Addendum 48 – UN Regulation No. 49

Revision 6 - Amendment 7

07 series of amendments – Date of entry into force: 7 January 2021

Uniform provisions concerning the measures to be taken against the emission of gaseous and particulate pollutants from compression-ignition engines and positive ignition engines for use in vehicles

Figure 12

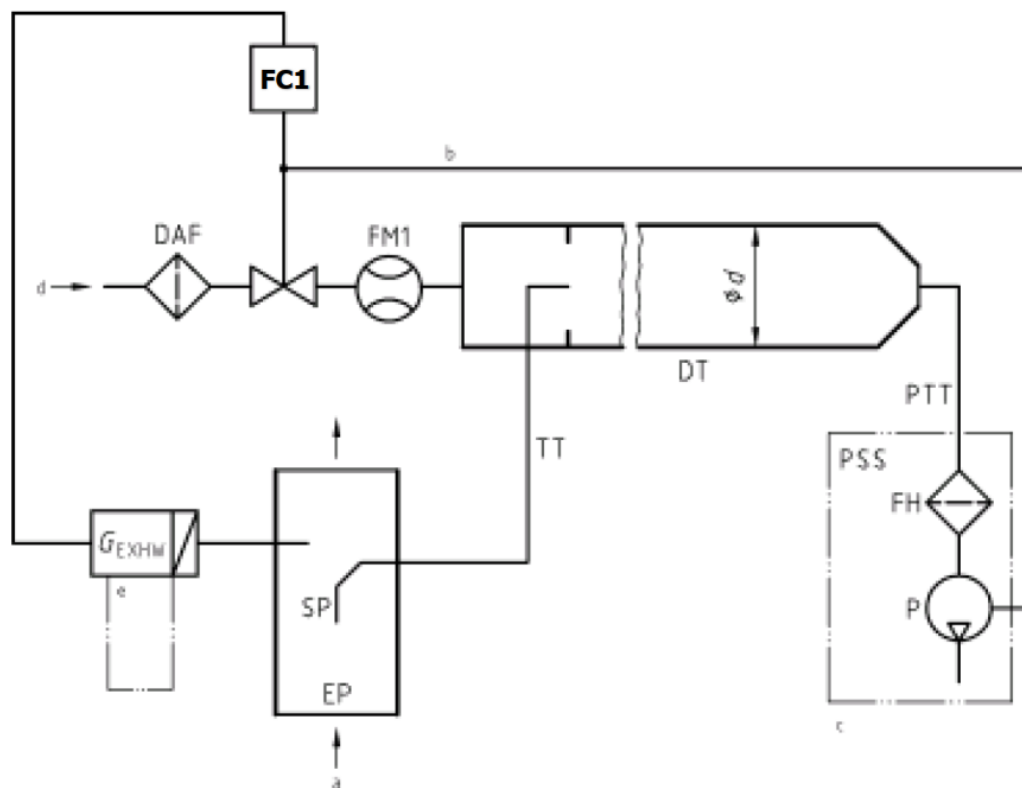
Paragraph A.2.2.1., amend to read:

Scheme of partial flow dilution system (total sampling type)

a = exhaust b = optional c = details see Figure 16
 ..."

Figure 1

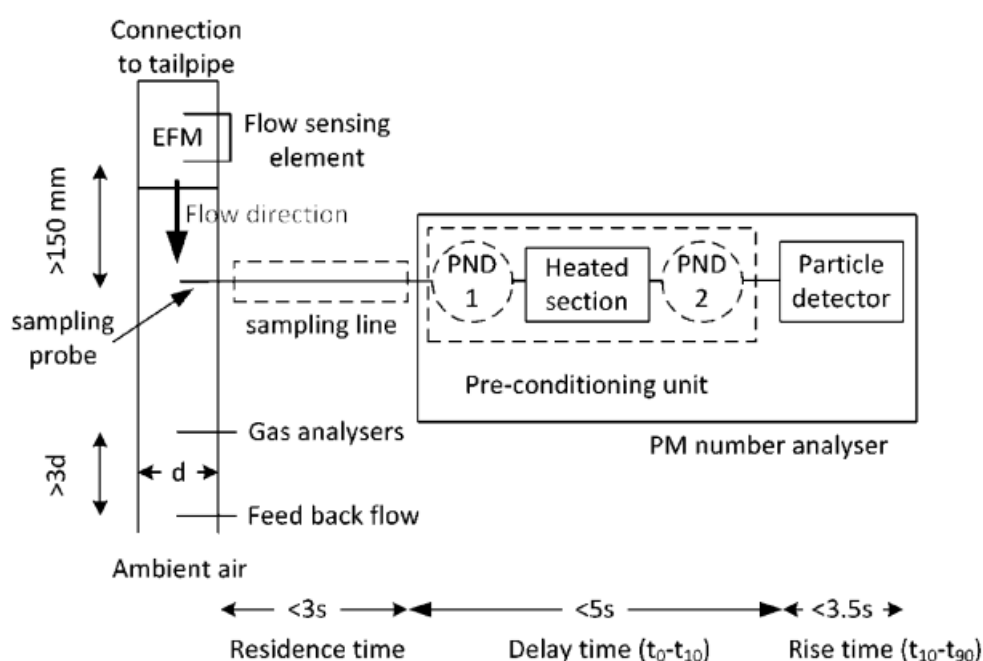
Add a new paragraph A.2.2.5., to read:

A.2.2.5.1.1. The PM number analyser shall consist of a pre-conditioning unit and a particle detector (see Figure 1). The particle detector may also pre-condition the aerosol. The analyser's sensitivity to shocks, vibrations, aging, variations in temperature and air pressure, electromagnetic interferences and other things that could affect the operation of the vehicle or the analyser shall be kept to a minimum as far as possible and shall be clearly stated in the supporting documentation produced by the instrument manufacturer. The PM number analyser shall fulfil the requirements of this Regulation and the specifications of the instrument manufacturer.

Example of a PM number analyser setup

Notes: dotted lines depict optional parts; EFM means Exhaust mass Flow Meter; d means inner diameter ; PND means PM Number Diluter
